**Characterization Work Plan for  
Subsurface Soil in the Eastern General Services  
Area Debris Burial Trenches  
Lawrence Livermore National Laboratory Site 300**

### **Responses to Regulatory Comments on the Draft and Draft Final Characterization Work Plan for Subsurface Soil in the Eastern General Services Area Debris Burial Trenches**

Figure 9. Eastern General Services Area Operable Unit site map showing proposed boreholes, wells, trenches, test pits and approximate area of debris pile.

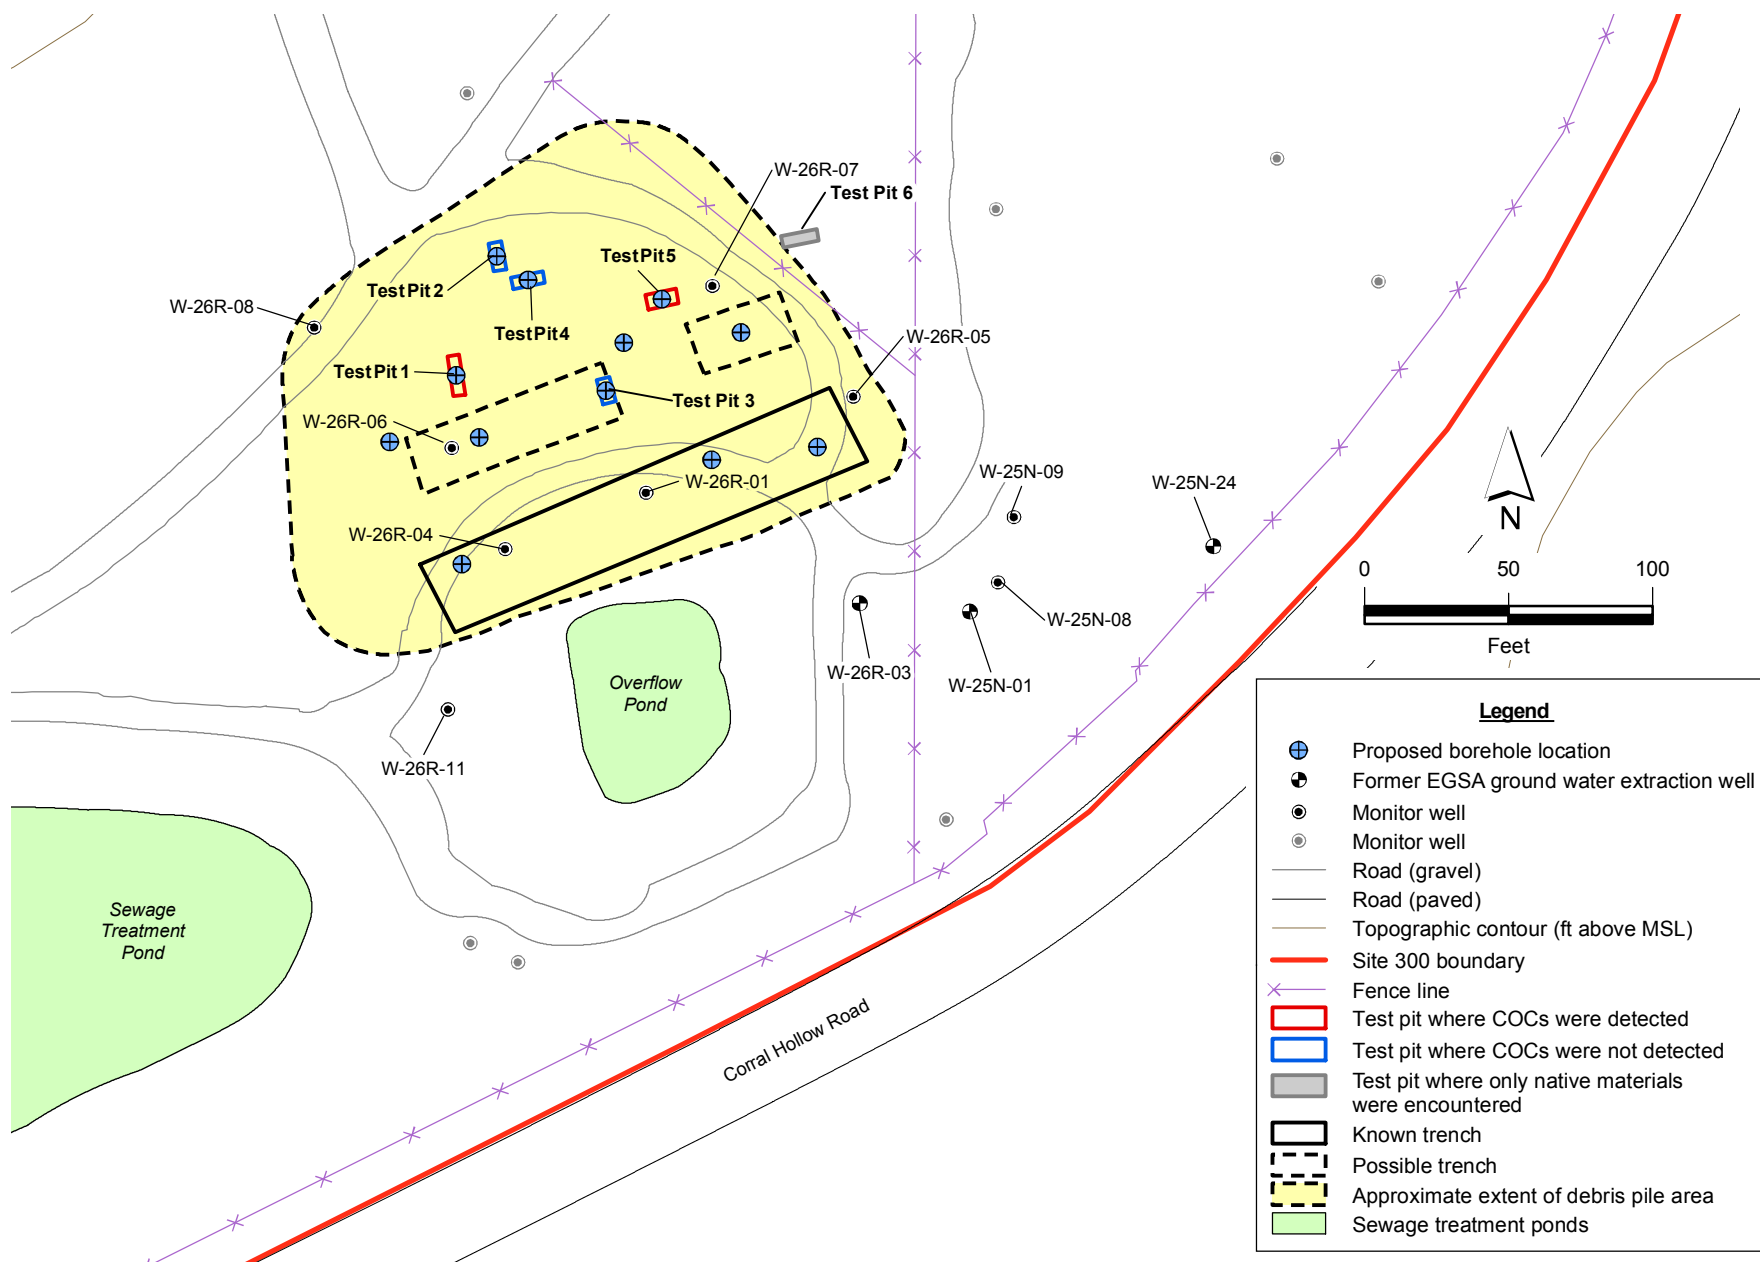
1. The GSU understands the proposed borehole locations shown on Figure 9 were determined using simple random sampling with the adaptive fill option as implemented in Visual Sample Plan (VSP) software. However, we note that none of those randomly selected locations were located within the easternmost debris burial trench identified in Figure 4.

Recommendation: Please consider moving at least one of the proposed sampling locations to the area that coincides with the easternmost debris burial trench identified in Figure 4.

4. Section 3.2.1, Borehole Drilling, Page 9 and Figure 9, Proposed borehole subsurface soil sampling locations in the Eastern GSA Debris Burial Trench Study Area: EPA disagrees with the random grid approach (see General Comment 1). However, we are providing this specific comment in the context of the Lab’s decision to proceed with the original approach. Section 3.2.1 states, “The exact location of the 12 boreholes will be determined using a 3 x 4, 50 ft square grid that encompasses the 150 ft x 200 ft;” however, Figure 9 does not show the grid. In addition, Figure 9 shows that no boreholes are proposed in the northeastern trench identified from the aerial photographs (i.e., grey shaded areas). Lastly, it is not clear why four boreholes will be drilled along the existing roads. One of these boreholes should be moved to the northeast trench. Please revise Figure 9 to display the sampling grid. In addition, please revise Figure 9 to move one of the four boreholes to be drilled along the existing roads to the northeast trench.

2. Regional Water Board staff concur with the overall coverage of sample locations within the estimated boundary of the debris burial area as shown on Figure 9. However, sample coverage within the known locations of the actual burial trenches needs to be increased to ensure that the trenches are sufficiently sampled and hot spots are not missed, and to increase the level of confidence in drawing conclusions about the presence/absence of contamination. Therefore, at least two additional borings should be advanced within the depicted approximately 150 feet long by 25 feet wide trench; at least two additional borings within the approximately 75 feet long by 24 feet wide trench; and at least one boring within the approximately 65 feet long by 24 feet wide trench. Additionally, at least one boring should be placed within each former test pit location where COCs had been detected.

**Response:** At the July 22<sup>nd</sup> RPM meeting, DOE/LLNL proposed alternate drilling locations that included relocating three of the random borehole locations and adding two boreholes within the known debris burial trench locations as requested in DTSC's General Comment #1, EPA's Specific Comment #4, and the RWQCB's General Comment #3.

**On August 1, 2014, DOE/LLNL provided a map of the new borehole locations based on this agreed-upon approach. EPA, the RWQCB, and DTSC concurred with the new locations that are presented in Figure 9 of this work plan on August 11 and 12, 2014, respectively.**

**The text in Section 3.2.1 and Figure 9 have been modified to reflect these changes.**

**On August 1, 2014, DOE/LLNL provided a map of the new borehole locations to the regulators based on this agreed-upon approach. On August 11 and 12, 2014, the regulatory agencies concurred with the new locations, which are presented in Figure 9 of this work plan.**

**The text in Section 3.2.1 and Figure 9 have been modified to reflect these changes.**

On August 1, 2014, DOE/LLNL provided a map of the new borehole locations to the regulators based on this agreed-upon approach. On August 11 and 12, 2014, the regulatory agencies concurred with the new locations that are presented in Figure 9 of this work plan.

The text in Section 3.2.1 and Figure 9 have been modified to reflect these changes.
